Value Engineering Study

**US 27 RECONSTRUCTION
FROM US 150 BYPASS IN STANFORD TO KY 34
LINCOLN AND GARRARD COUNTIES, KENTUCKY**

**ITEM NUMBER 7-196.00
VE STUDY NUMBER 201204**

Final Report

Recommended Design

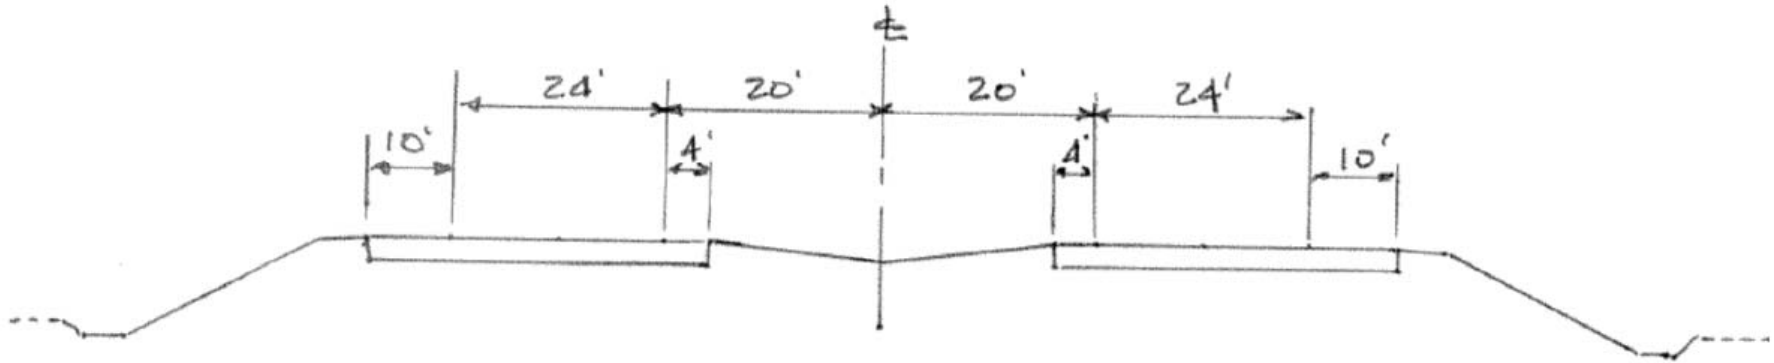
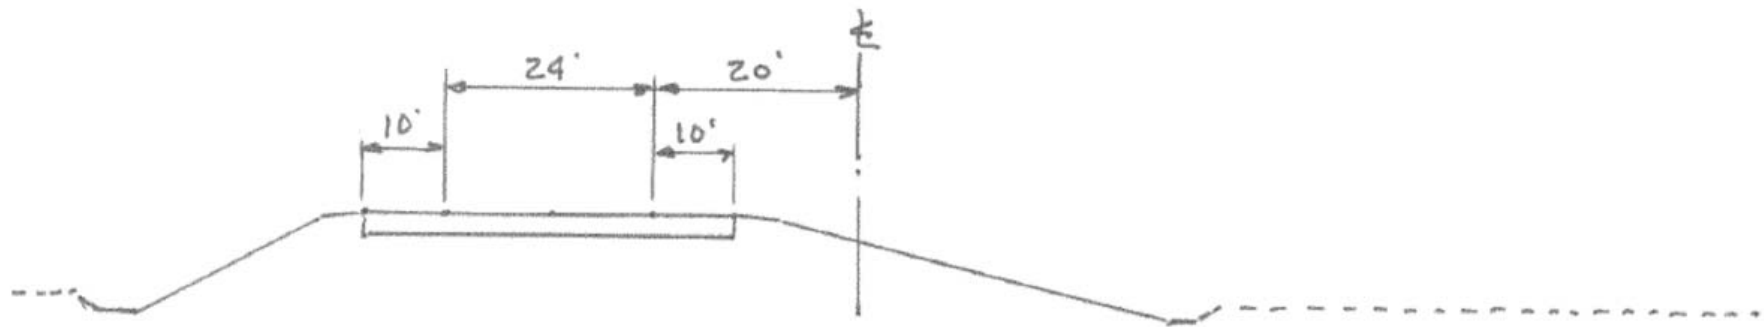
The VE Team recommends that the portion of the project north of the Lancaster Bypass be constructed initially with a typical section having two 12-foot lanes and 10-foot paved shoulders plus an added left turn lane to selected side/cross roads. The 2 lanes could be constructed offset from the centerline to become the future southbound lanes. Initial ROW would be purchased for the ultimate; however, northbound pavement, shoulder, and some of the grading would be deferred until such time as warrants and finances permit, which could allow more traversable side slopes on the east side with less guardrail.

The traffic study indicates that, in the design year, the projected ADT in this segment is likely to be less than 12,000 vehicles and could be accommodated by a two-lane roadway with an acceptable level of service. The future northbound pavement could be added at a later date with minimal disruption.

Recommended Design

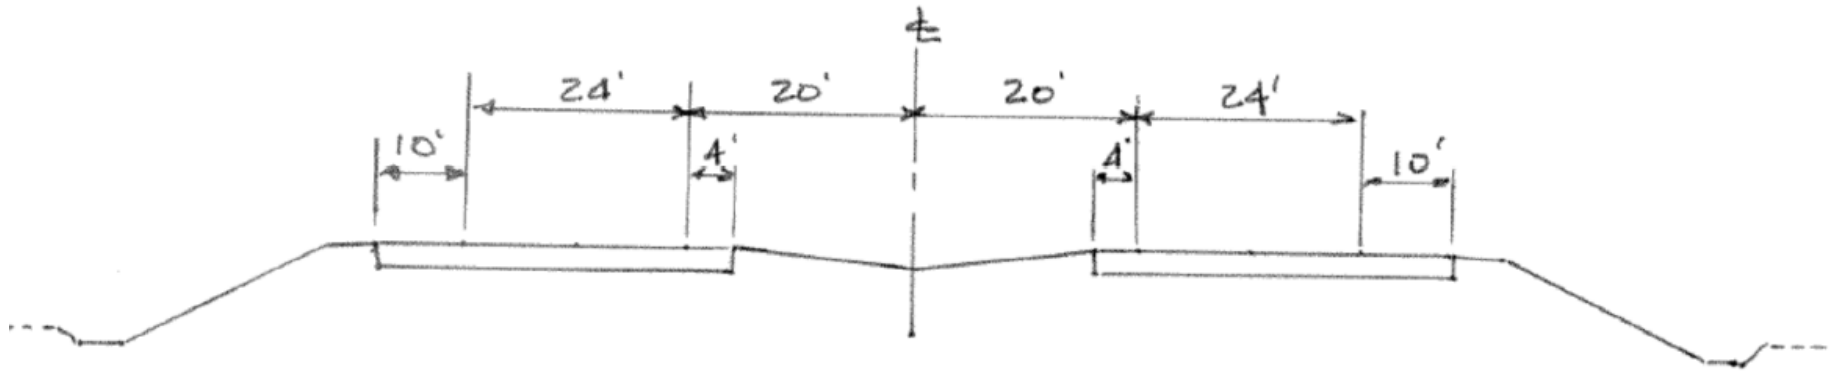
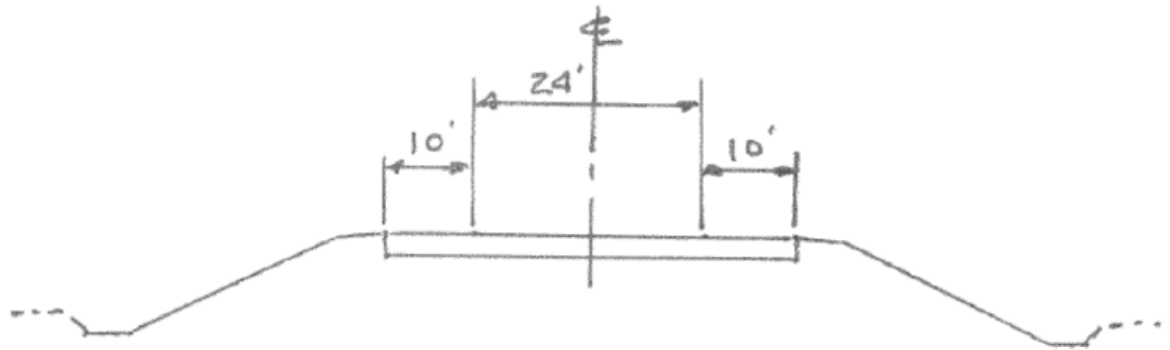
The VE Team recommends that, in the Lancaster Bypass portion of the project, the typical section be constructed with two 12-foot lanes and 10-foot paved shoulders plus an added left turn lane to selected side/cross roads.

The traffic study indicates that, in the design year, approximately half the traffic from the US 27 corridor would use existing US 27 through downtown and approximately half would use the Bypass. The projected Bypass ADT is likely to be roughly 10,000 vehicles and could be accommodated by an access-controlled, two-lane roadway with an acceptable level of service. In addition, there will be redundancy and additional north-south capacity on the existing US 27 through Lancaster.

Recommended Design – 2 + 1

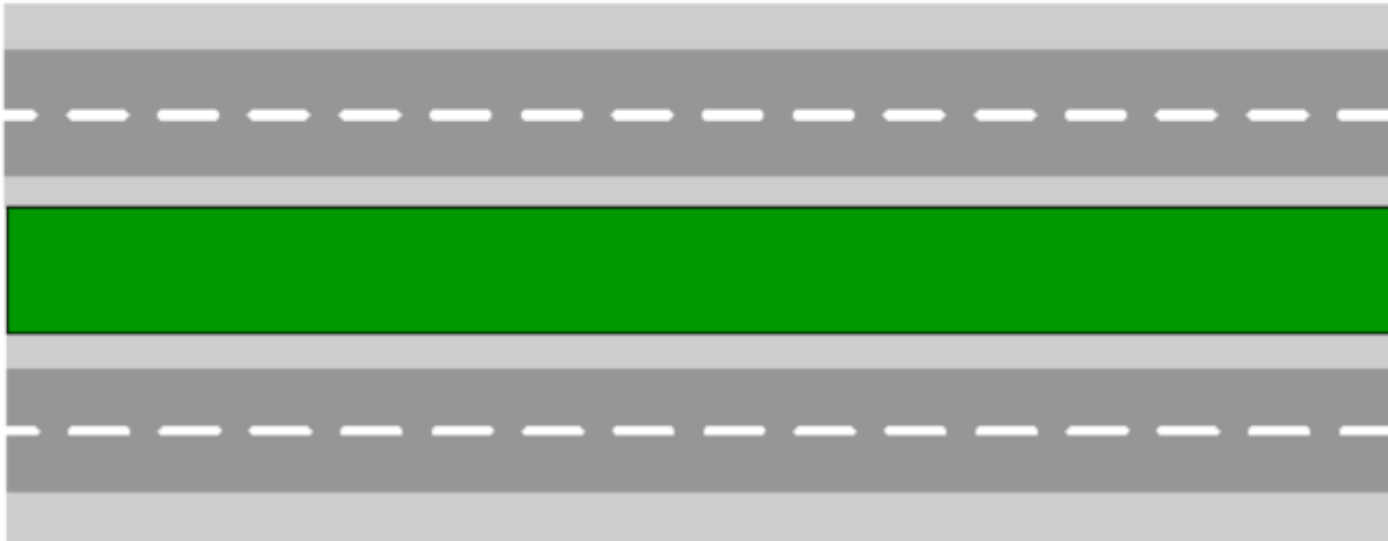
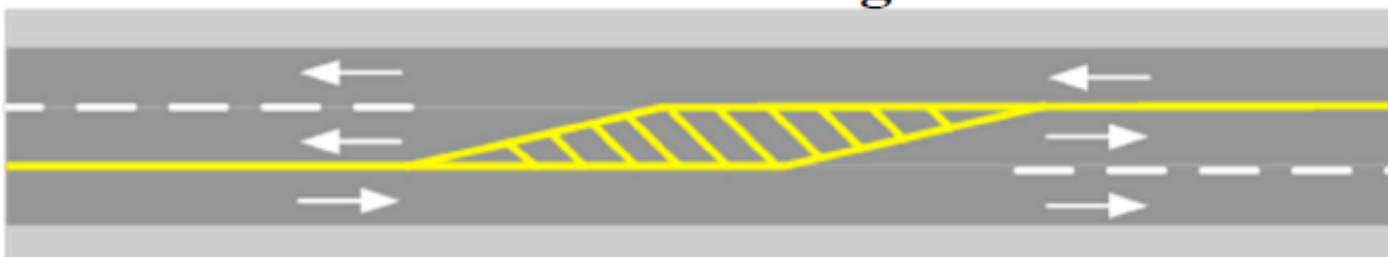
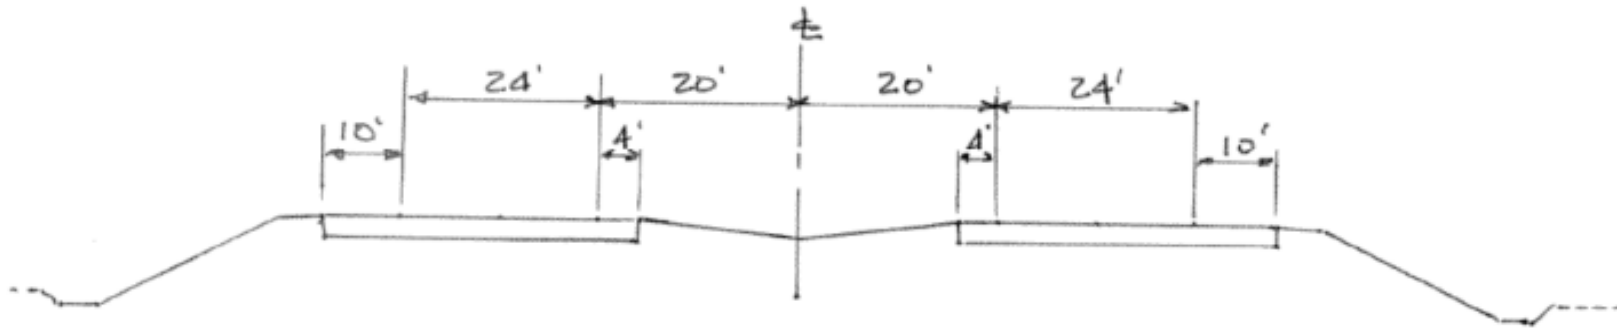
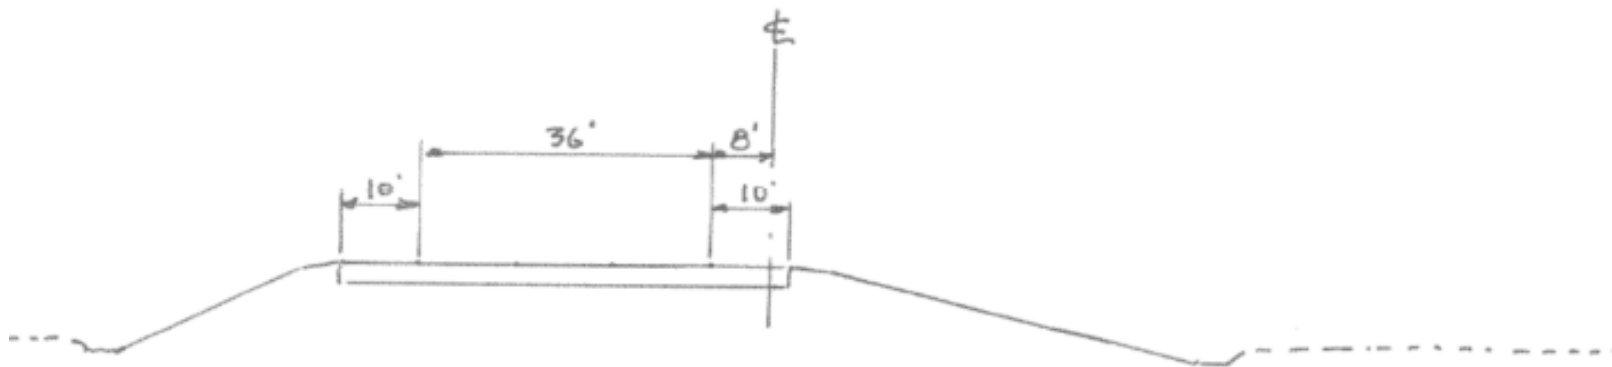
The traffic study indicates that, in the design year, the projected corridor ADT is likely to be less than 12,000 vehicles and could be accommodated by a 2 plus 1 configuration with a high level of service. Should additional capacity be needed, future northbound pavement could be added at a later date with minimal disruption.

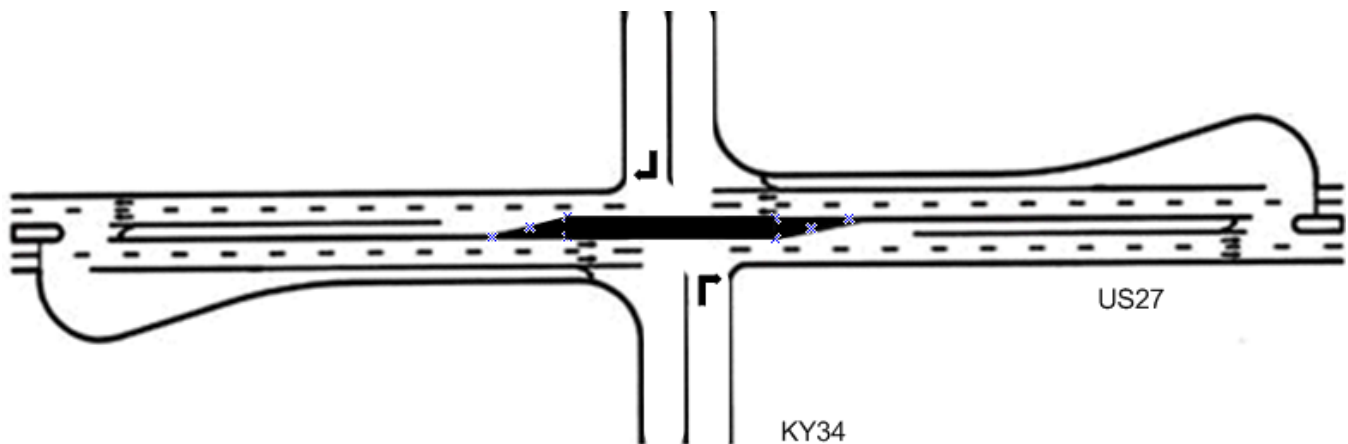
The preferred alternative for the reconstruction of US27 crosses gas transmission lines multiple times throughout the project length. Although these facilities are buried, the large volume of proposed fill along with general construction impacts requires possible utility relocation and/or casing of the pipes. This contributes to a high utility cost for the length of this project. The project is early in the design process causing uncertainty and therefore contributing to conservative utility cost estimates. The design team expressed that the utilities prefer to avoid being spanned by structure, but given the high cost of relocation the VE Team believes this option should be fully vetted during the design process. The drawback of this approach is a lack of access for the utility as well as additional structure maintenance costs. Structures available to span the utilities include three-sided box culverts or small precast concrete beam structures.

SKETCH OF RECOMMENDED DESIGN

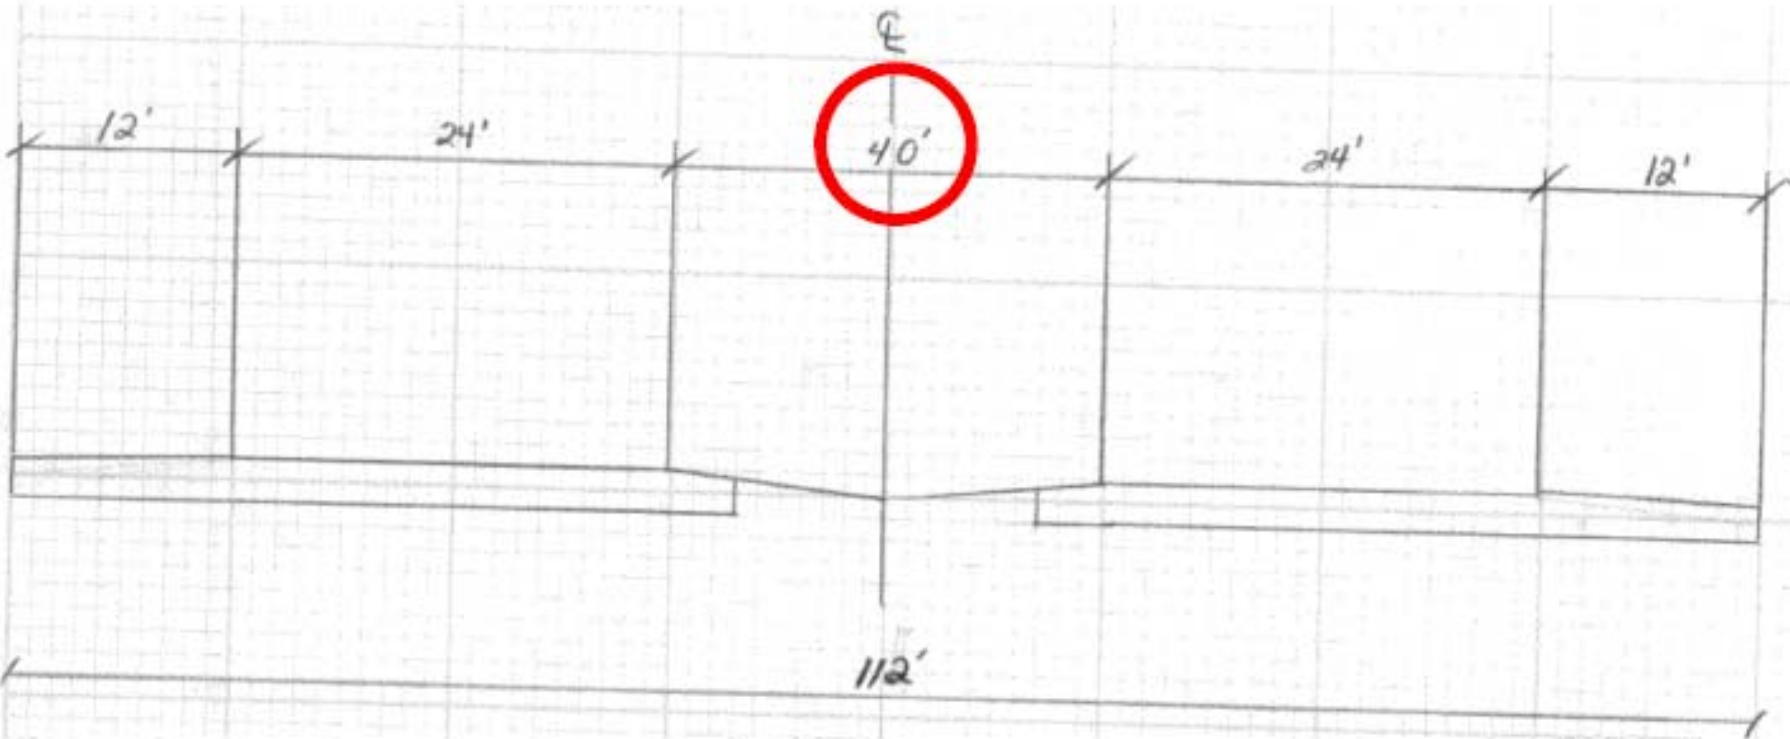
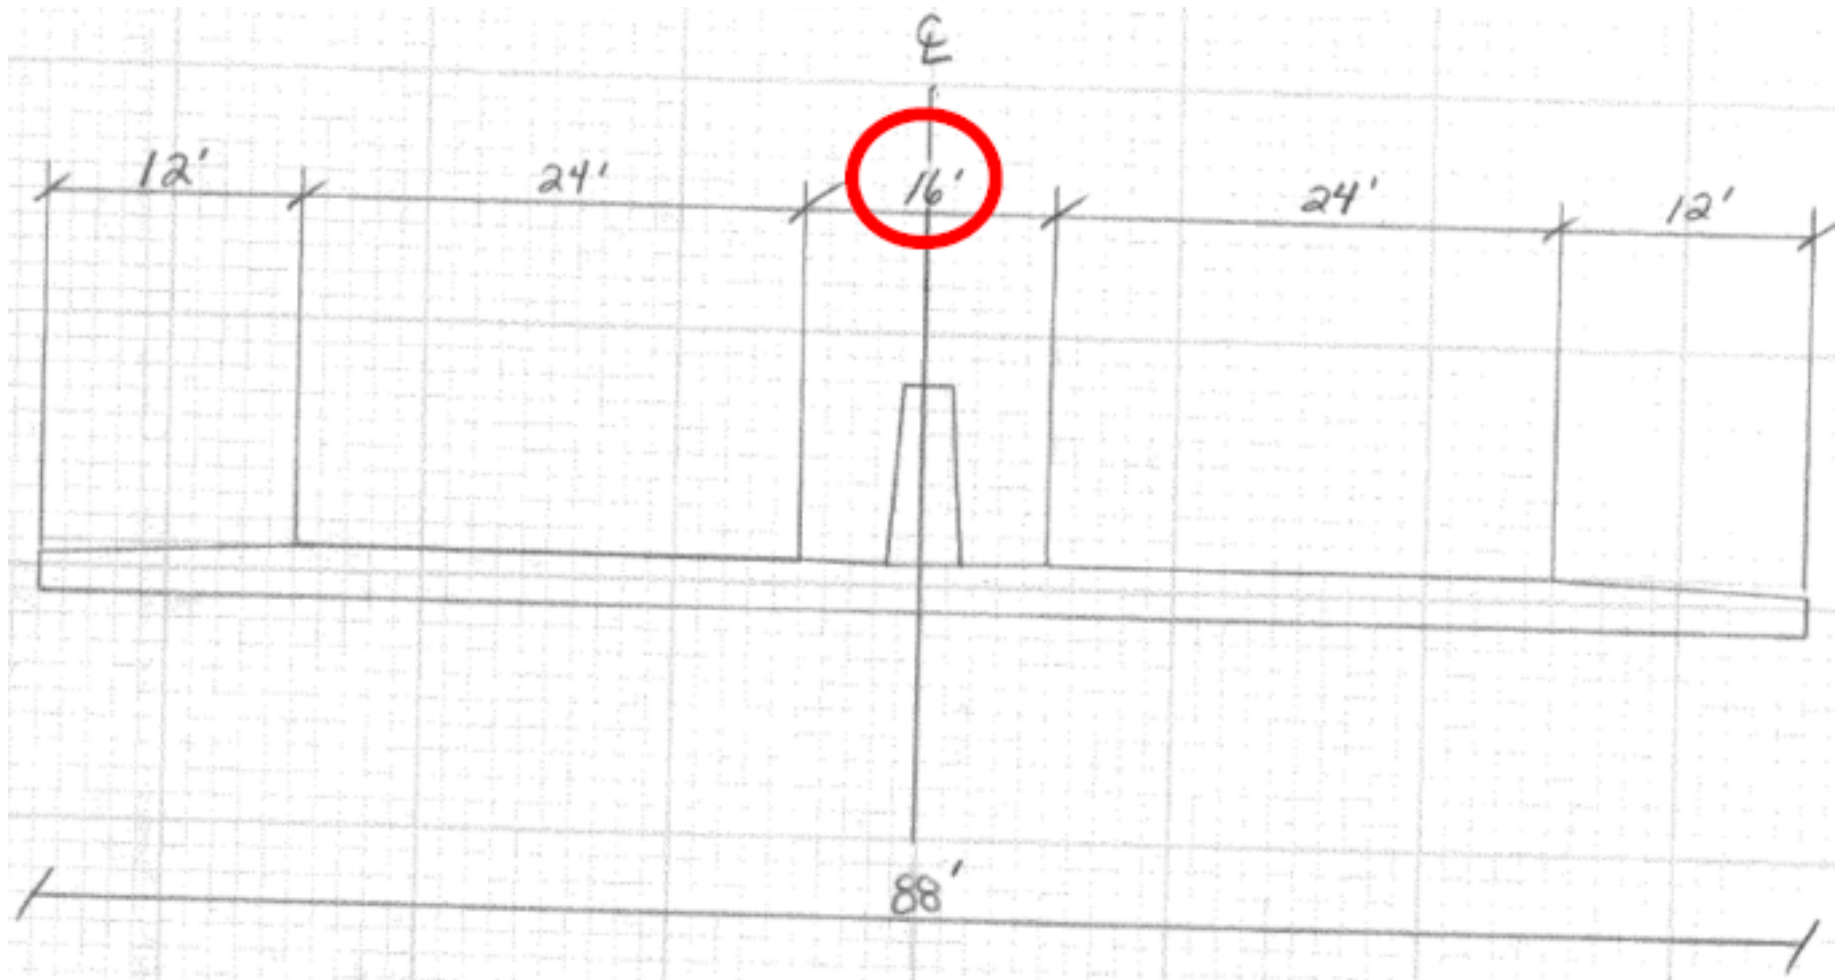
The VE Team recommends using a 4-lane typical section with a 16-foot median and Jersey barrier to replace the 40-foot depressed median. This typical section shall begin approximately at Sta. 1250+00 and continue throughout the remainder of the corridor.

This 5% ROW reduction along the rural portion of the project will reduce one of the large budget items. This recommendation will also add the cost to include a permanent barrier.
